North Plains Connector LLC
North Plains Connector Transmission Project
Docket No. PU-26-82

Late-Filed Exhibit 17 – Route Adjustments

Late-Filed Exhibit 17-1 **Route Adjustment – Avoidance of Sensitive Site** North Plains Connector Project Oliver County, North Dakota

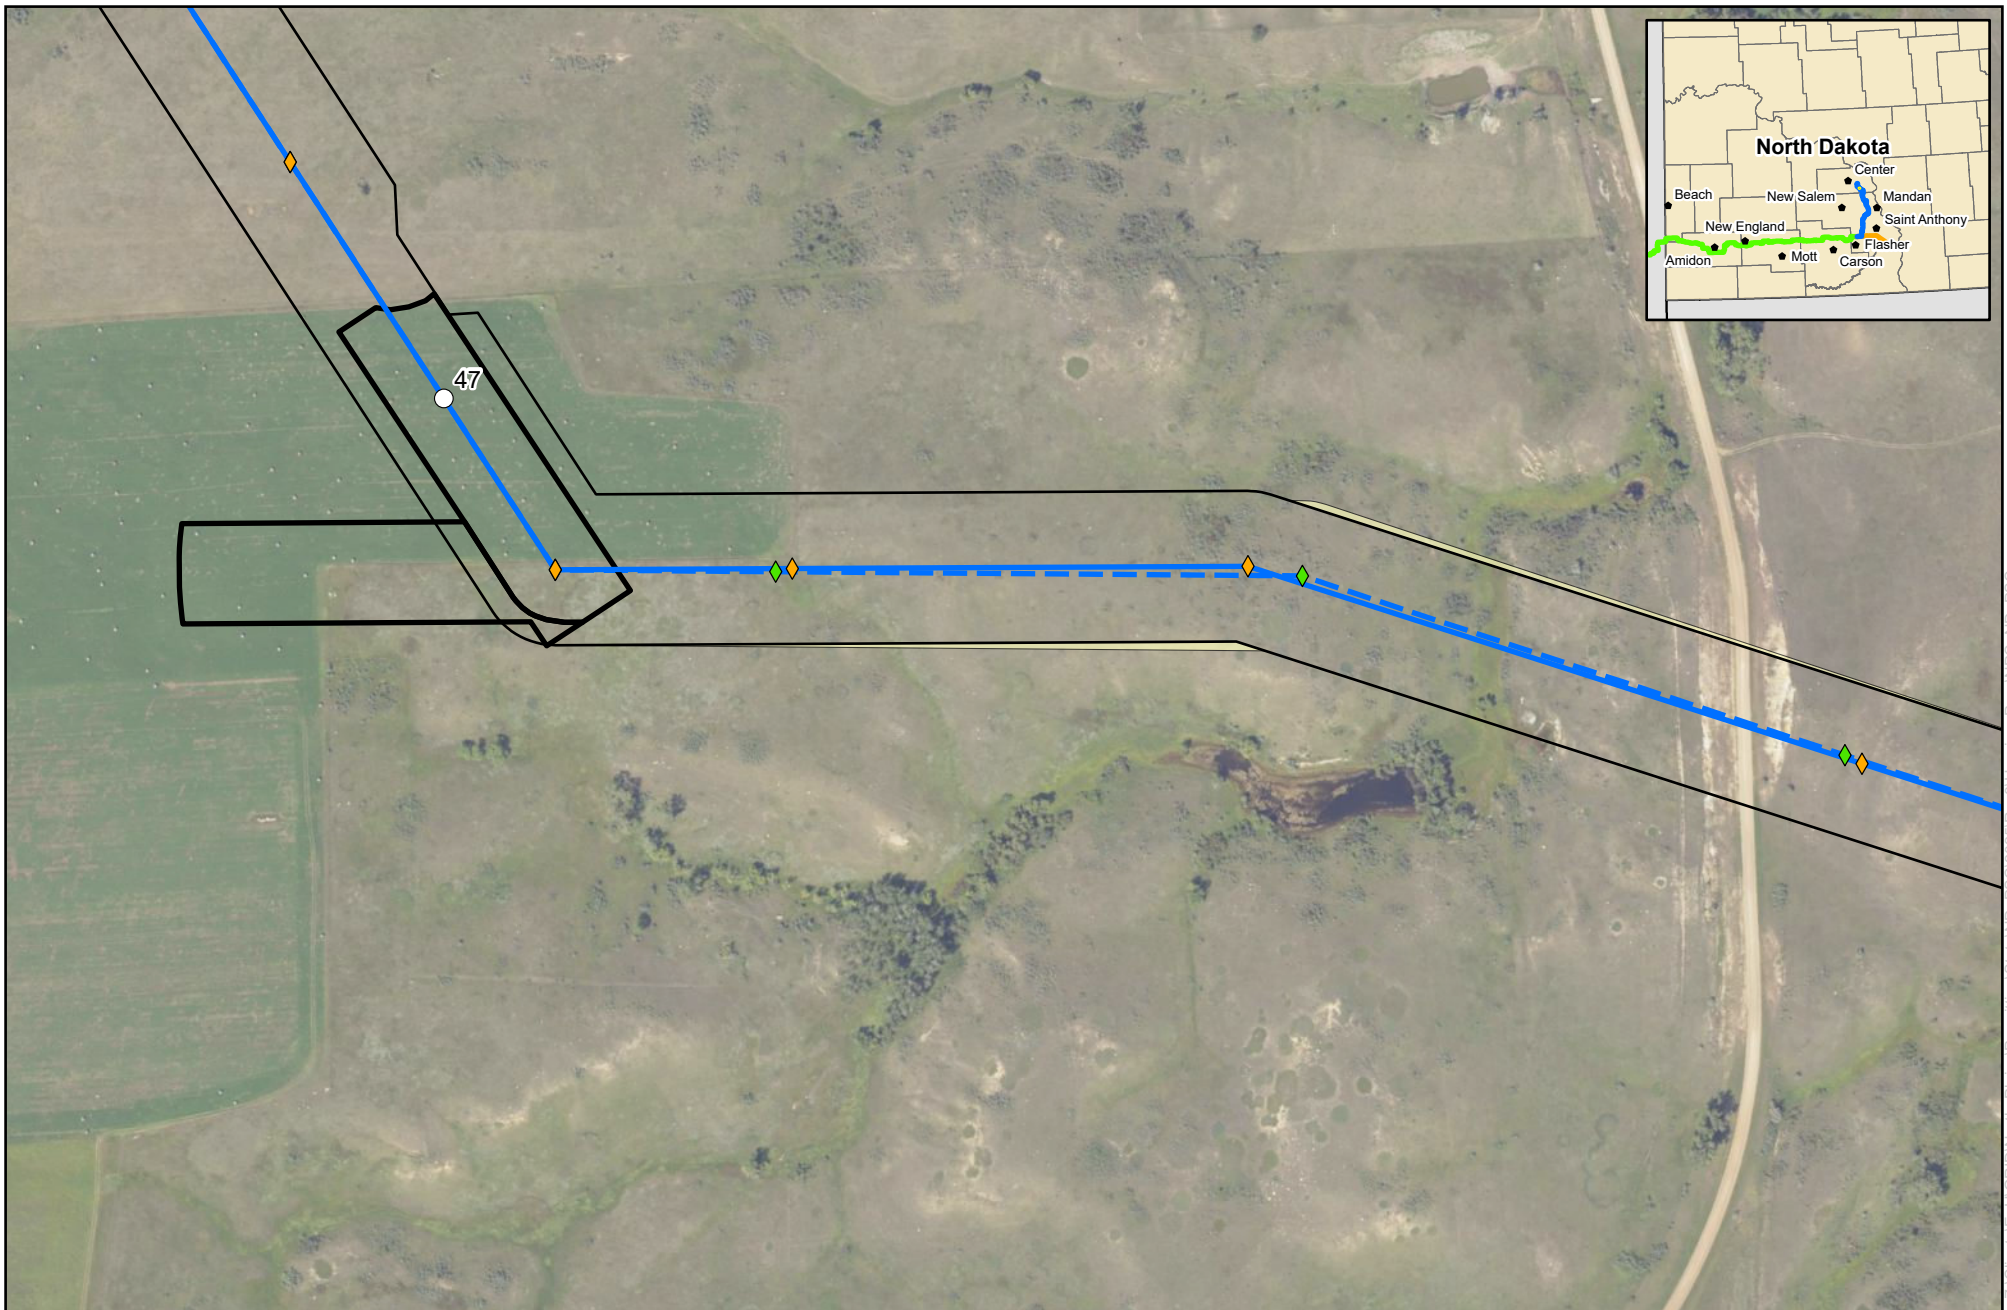
In his testimony, Brant Johnson testified regarding a proposed route adjustment in Oliver County to avoid a sensitive resource. The finalized Route/Corridor adjustment is depicted in the attached **Late-Filed Exhibit 17-1**. The Route/Corridor adjustment complies with the North Dakota Public Service Commission’s (“PSC”) exclusion area and avoidance area criteria, was discussed with the landowner, and is covered by the existing easement option agreement.

Late-Filed Exhibit 17-2

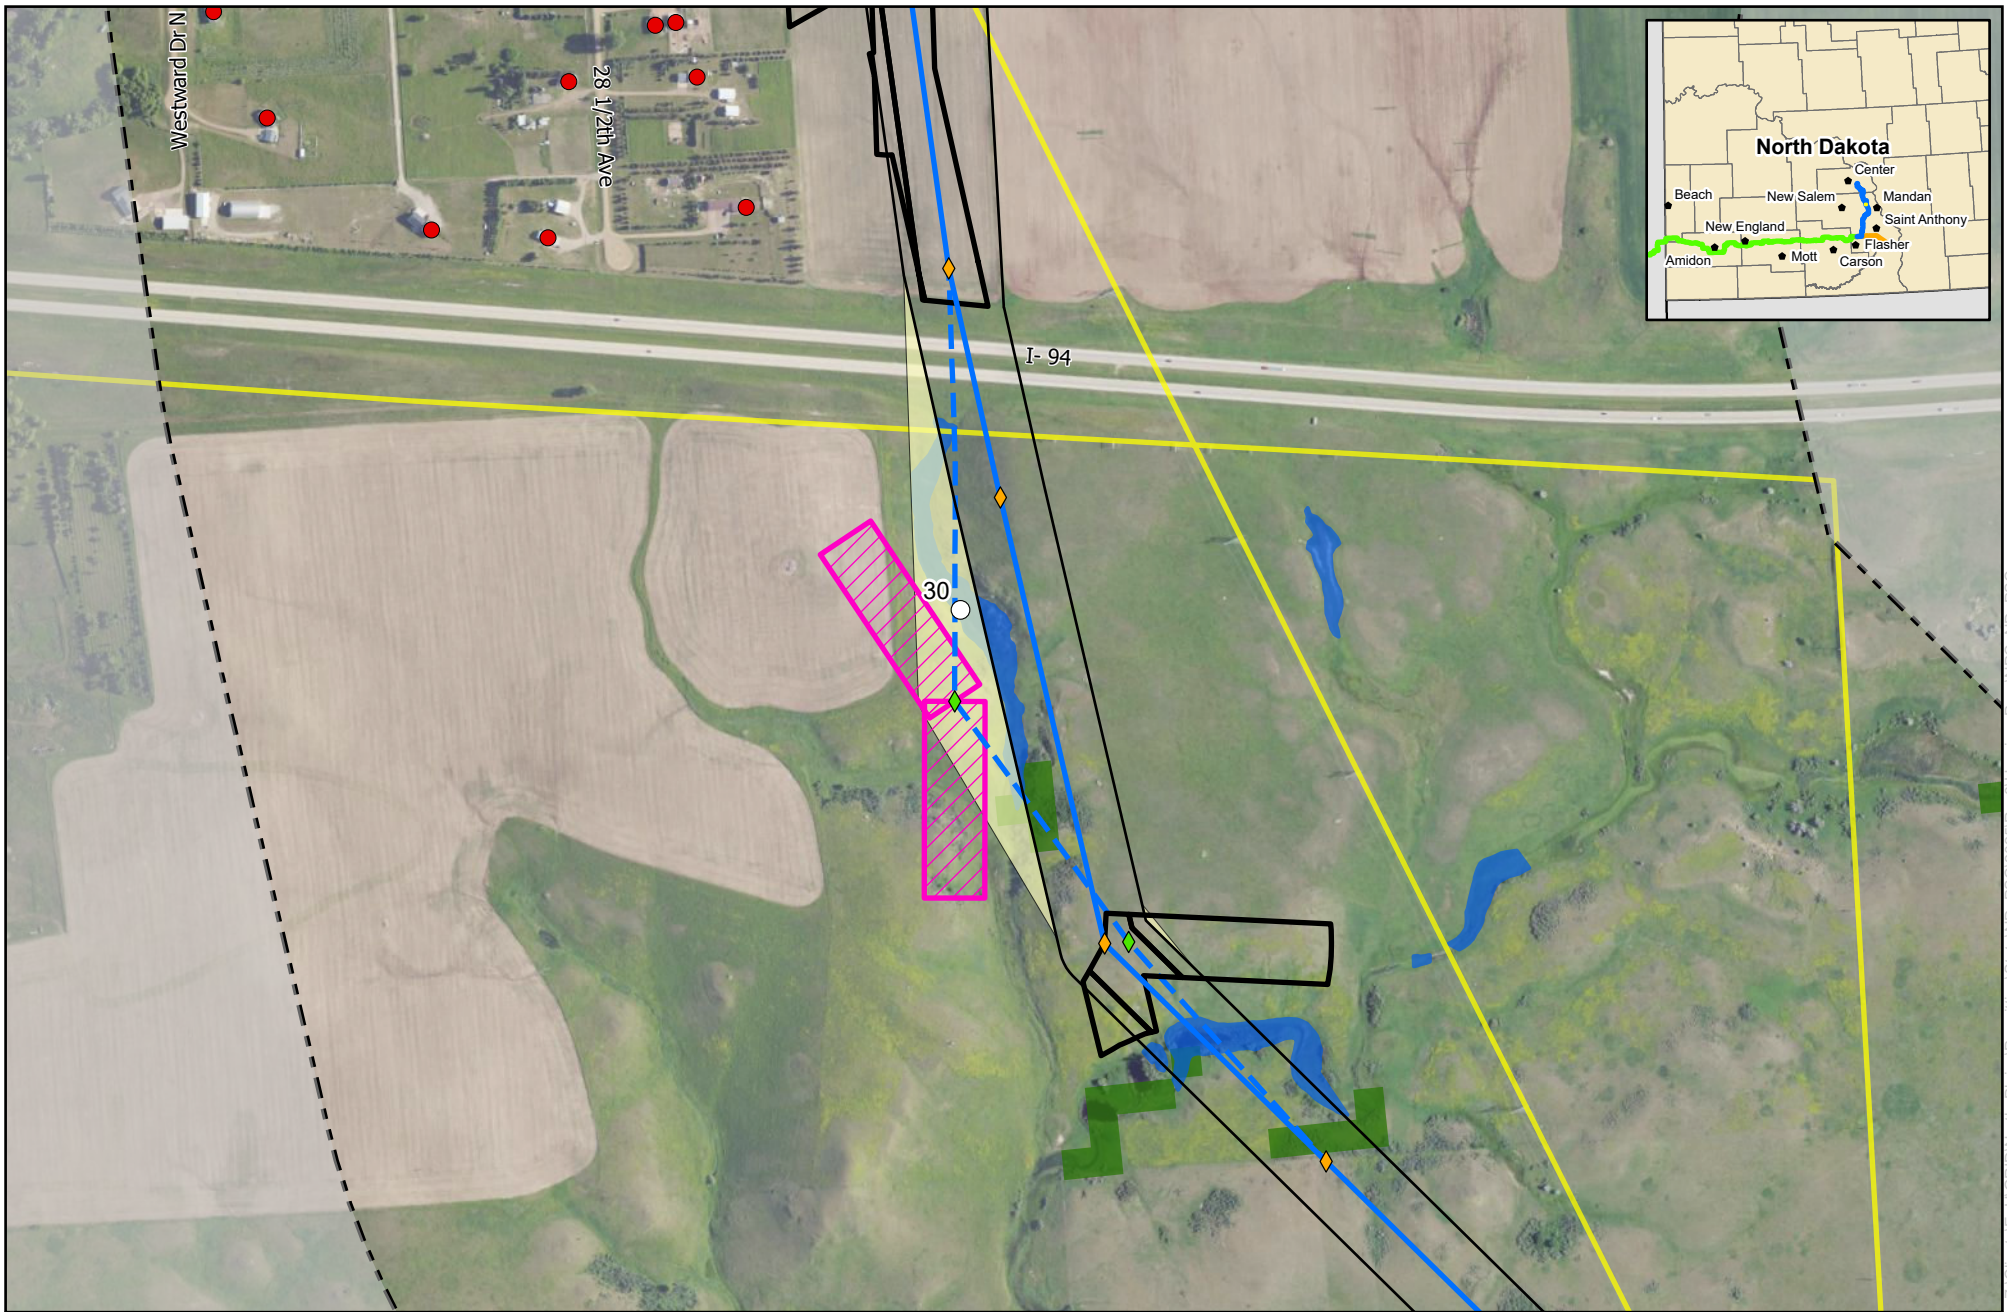
In his testimony, Brant Johnson discussed two proposed route adjustments to avoid section line right-of-way in Morton County. One finalized Route/Corridor adjustment is depicted in the attached **Late-Filed Exhibit 17-2**. The Route/Corridor adjustment complies with the PSC’s exclusion area and avoidance area criteria, was discussed with the landowner, and is covered by the existing easement option agreement.
